Gulf State

3

SUNDRY NOTICES AND REPORTS ON WELLS

GULF STATE No. 3

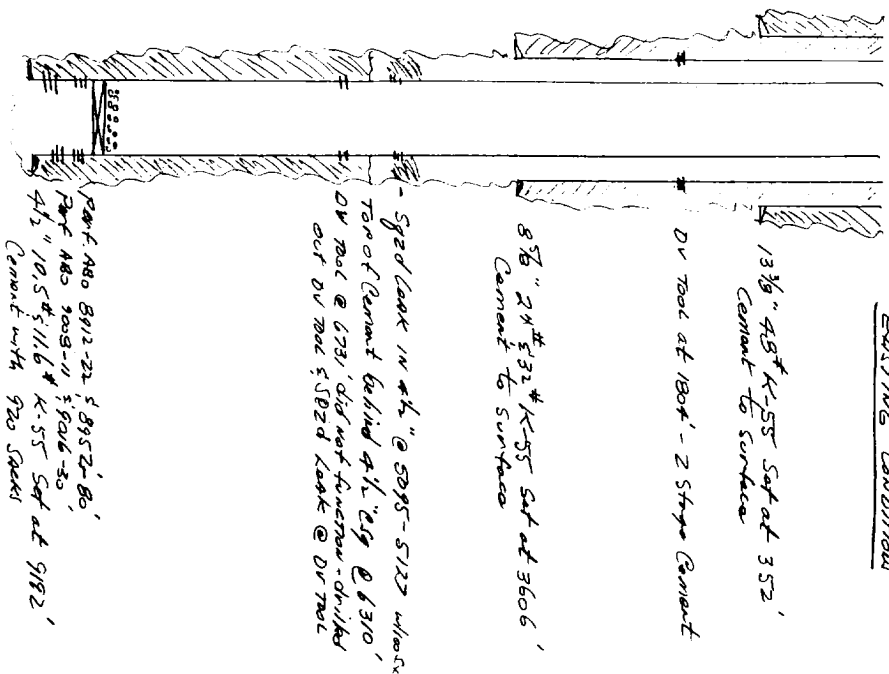
100' cement plug at 1000'
all plugs must be set thru the
20 x min plug
